SITE: Fernhurst Pk/Syngenta: Former Syngenta Site, Henley, Old Road, Fernhurst, Haslemere, West Sussex, GU27 3JE

Design Review Panel Workshop Meeting Notes

DATE: 18th July, 2016.

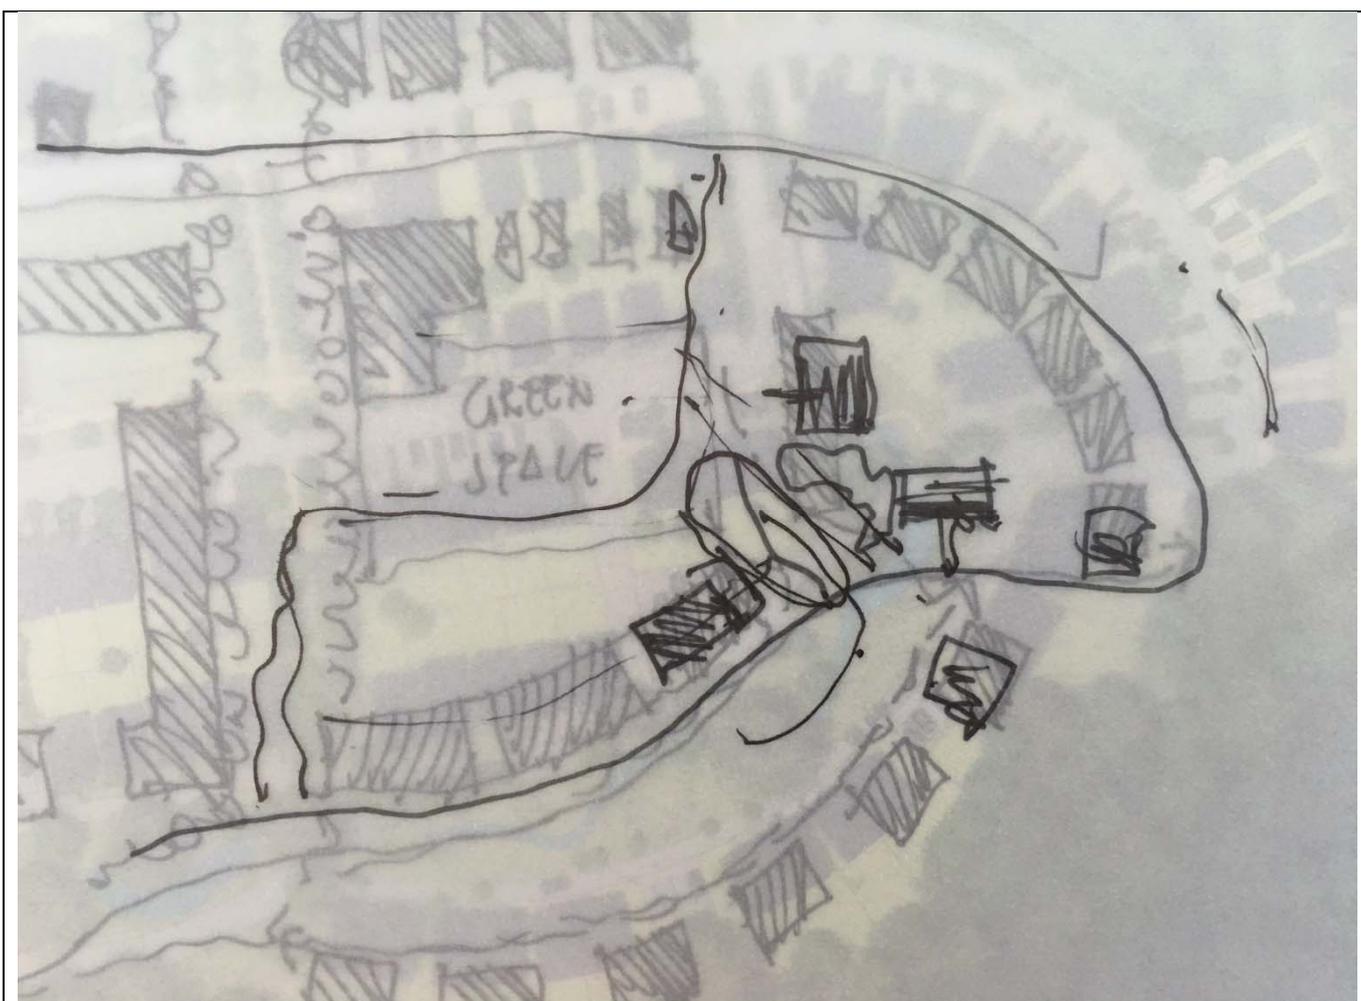
- TE reviewed and explained the landscape strategy so far and how the green fingers/shaws were based on areas of level changes and TPOs, which has made it challenging to create developable areas. The Panel Members said that they still felt that the development could be improved by merging some of the fingers, feeling that fewer more robust fingers would make a more significant impression and give the scheme a defined character.
- An agreed landscape strategy to inform the block structure was agreed:

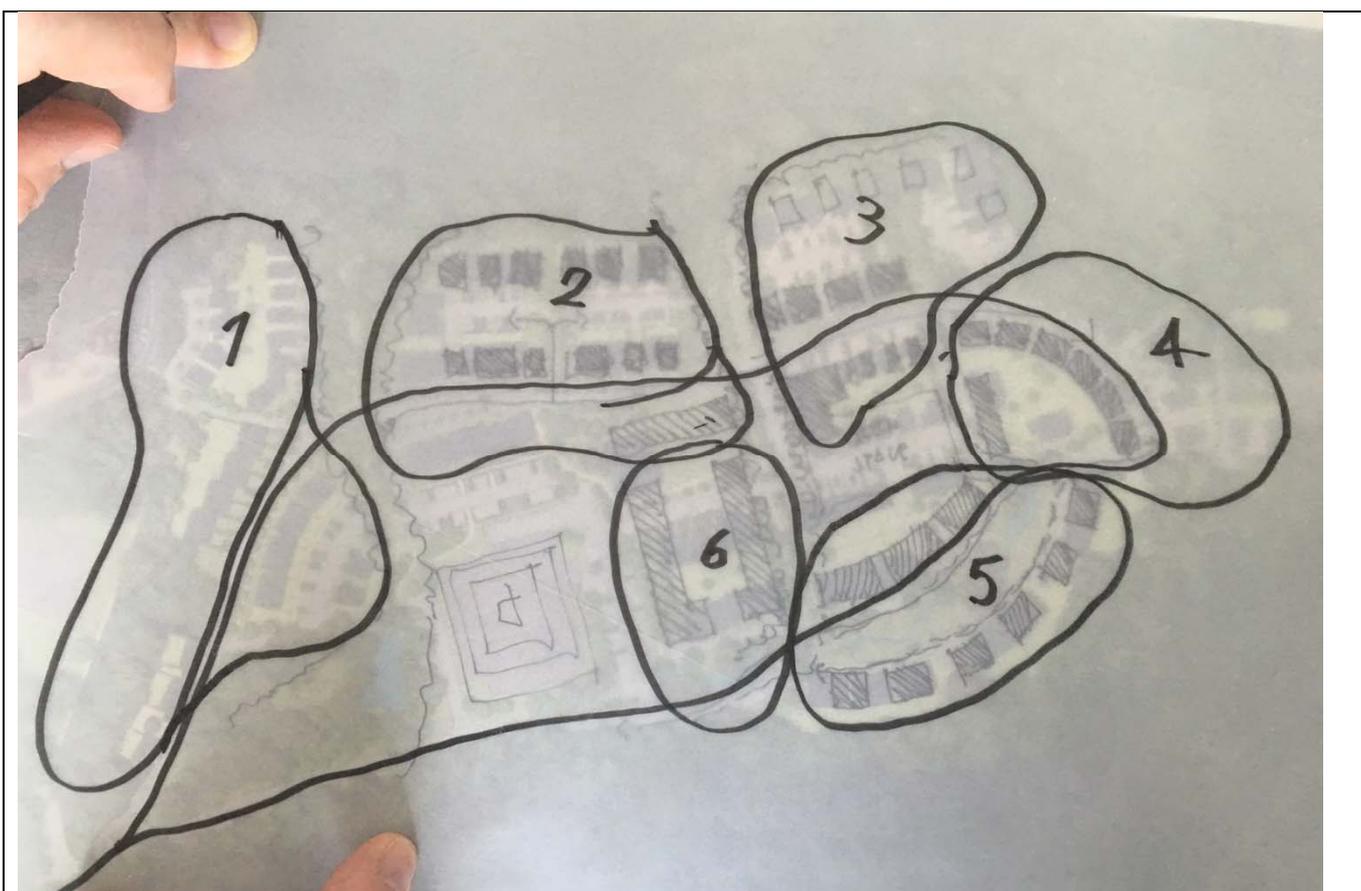
- Further to the initial concept of a series of pulses for the scheme (DRP session in May), and after establishing the landscape strategy as per above, the block structure was further explored. Although the benefits of underground parking on the north side is full understood (that it enables a reduction in the visual appearance of cars within the scheme), and the rationale for using the existing level changes for underground parking is appreciated. The Landscape and Design officers recommendation for moving the flats/higher density building forms to intensify the centre of the site and relate to the Pagoda building is strongly concurred by the DRP. The following sketch evolved from the workshop, which resolves the many issues with the block structure and it was agreed that this approach would be tested and re-drafted by TE/GH.
